ADDENDUM NO. ONE
FERNDALÉ PUBLIC SCHOOLS
2017 SINKING FUND PROJECTS
FERNDALÉ H.S. – KITCHEN / SERVING
AND CAFETERIA RENOVATION
Page 1 of 2 (write up only)

February 2, 2018

ADDENDUM NO. ONE to the plans and specifications for the FERNDALÉ PUBLIC SCHOOLS, 2017 SINKING FUND PROJECTS; FERNDALÉ H.S. – KITCHEN/ SERVING AND CAFETERIA RENOVATION, Ferndale, MI, Architect's Project No. 171745, dated January 15, 2018.

SKETCH SK-1

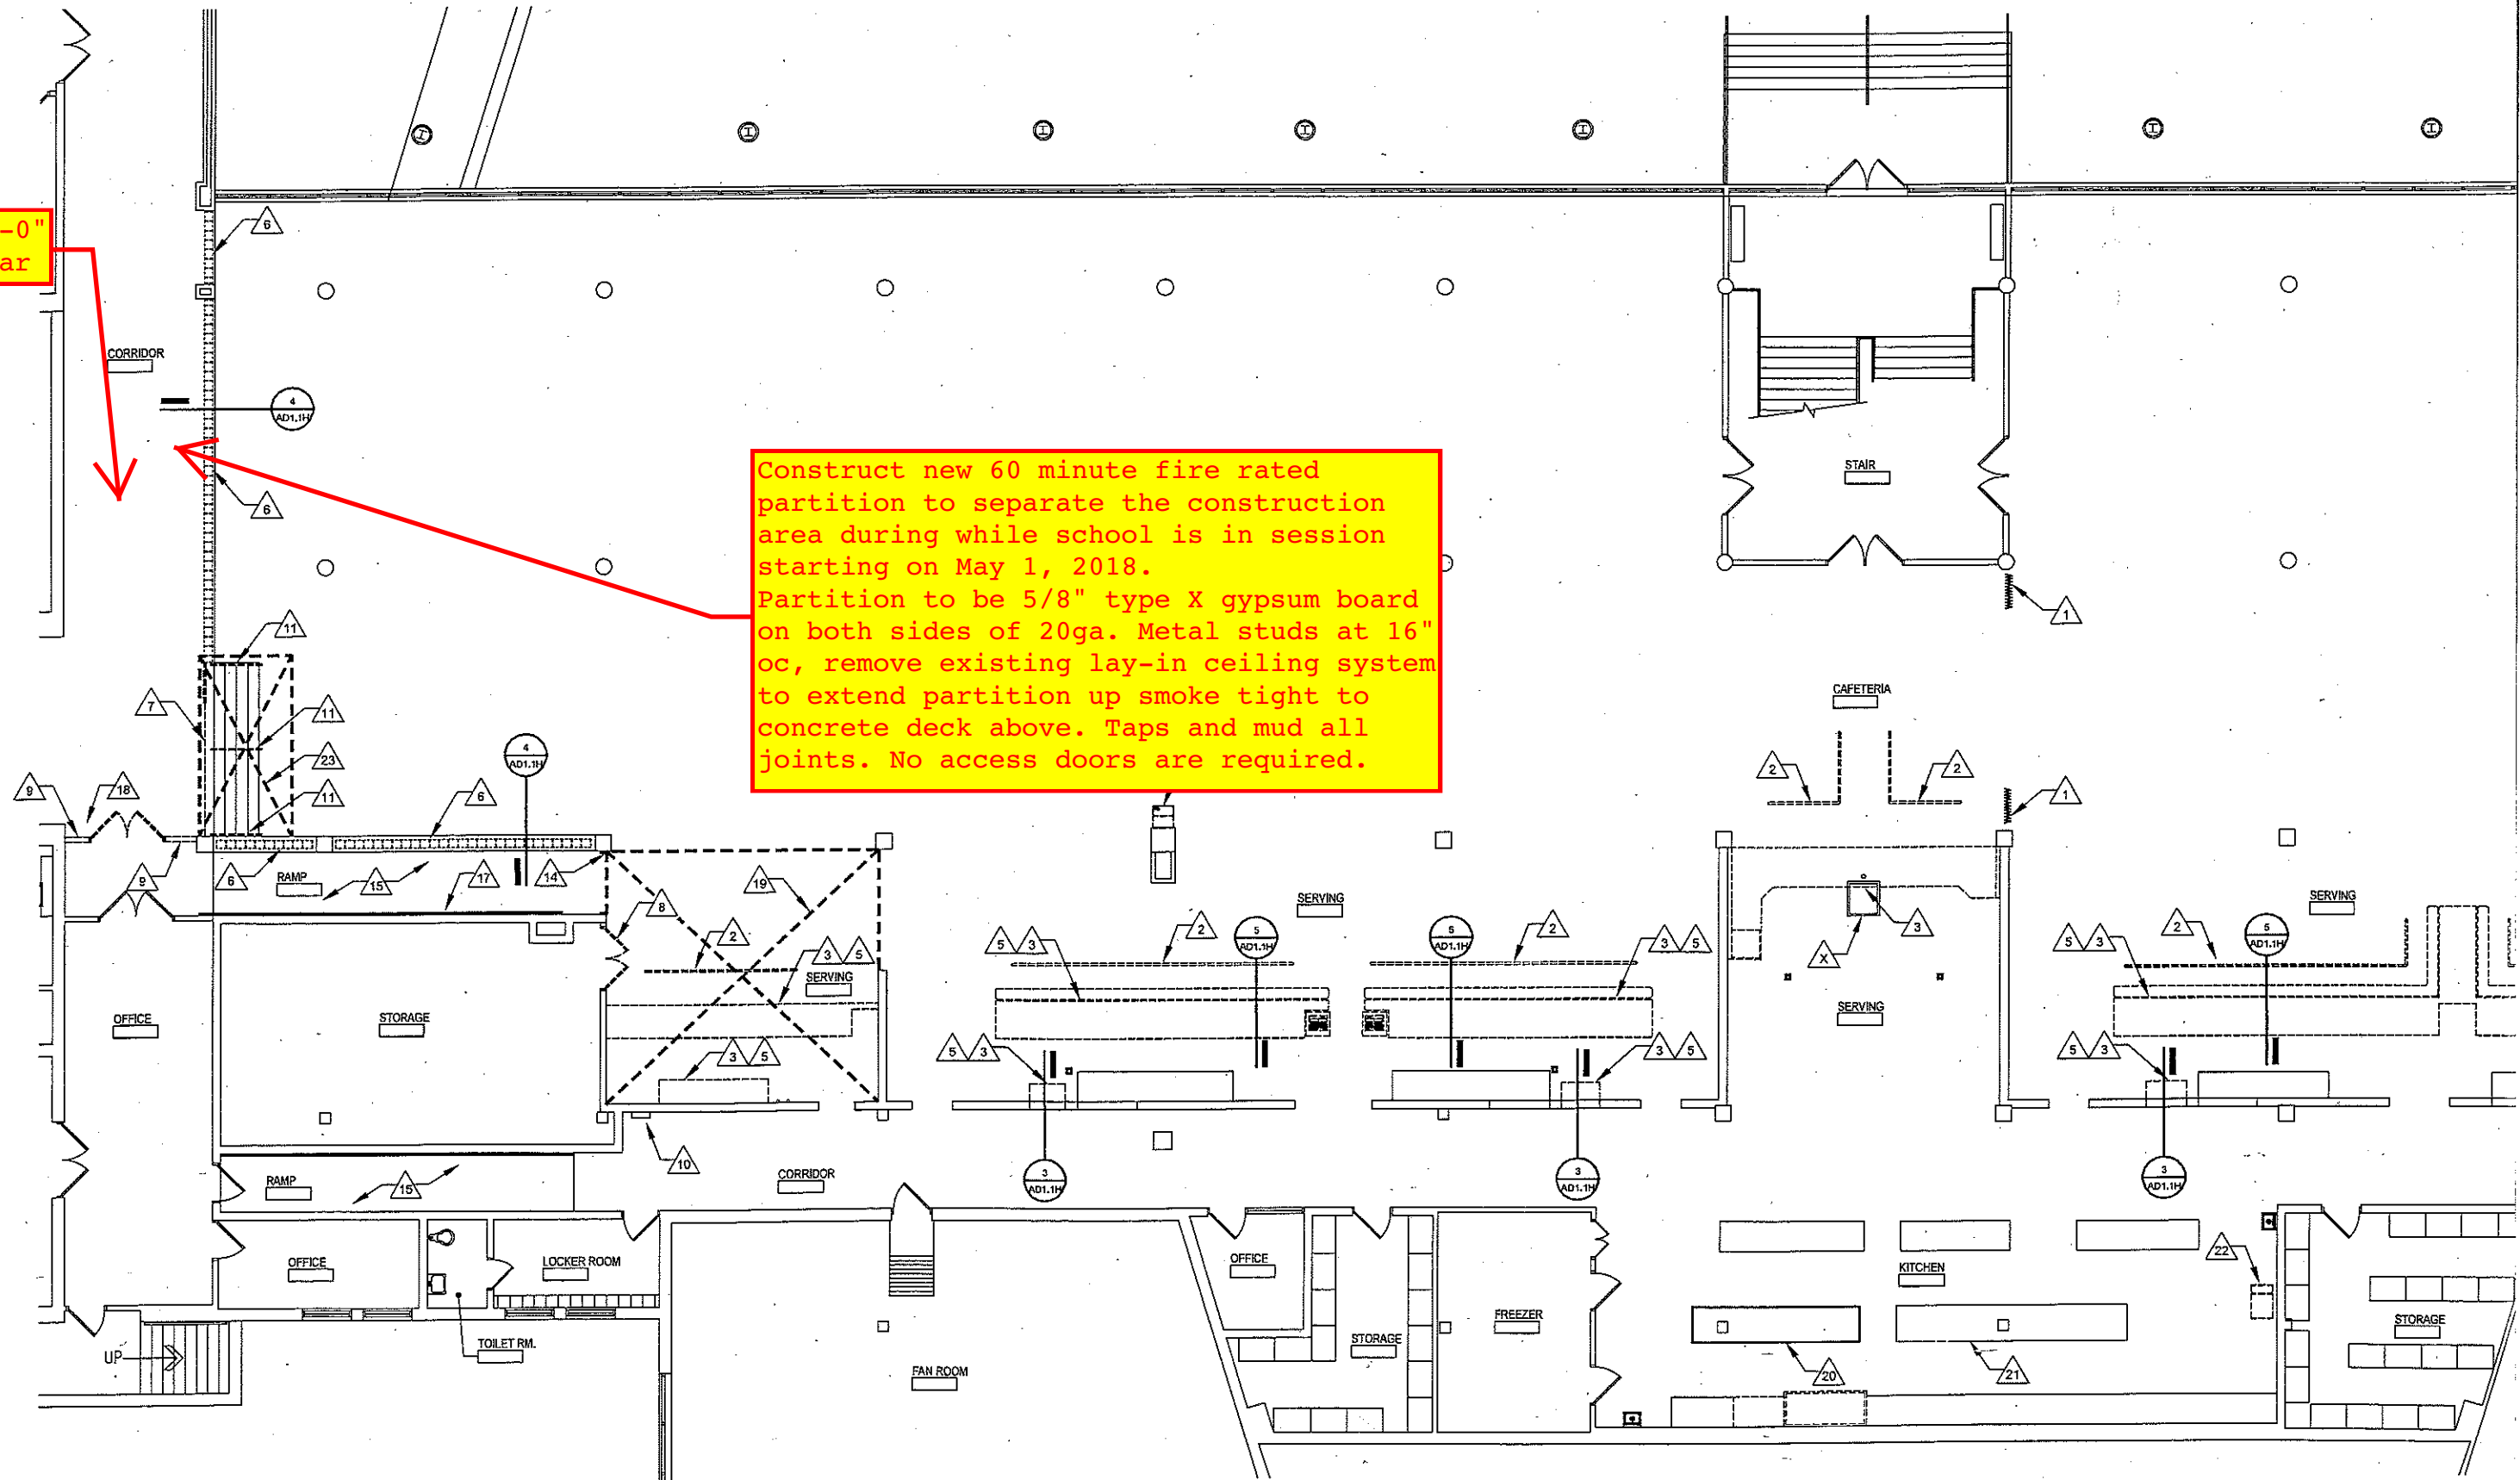
ITEM NO. 2: Refer to Sketch SK-1 (issued):
This work is to be included in the Summary of Work- Proposal A: General Trades Category; Refer to Sketch SK-1 for the location of new 60 minute fire rated temporary walls to be constructed in the Cafeteria 01 and Corridor 02 to separate the construction area while work will be in progress during the school year starting on May 1, 2018.

Maintain 6'-0" minimum clear

Construct new 60 minute fire rated partition to separate the construction area during while school is in session starting on May 1, 2018. Partition to be 5/8" type X gypsum board on both sides of 20ga. Metal studs at 16" oc, remove existing lay-in ceiling system to extend partition up smoke tight to concrete deck above. Taps and mud all joints. No access doors are required.
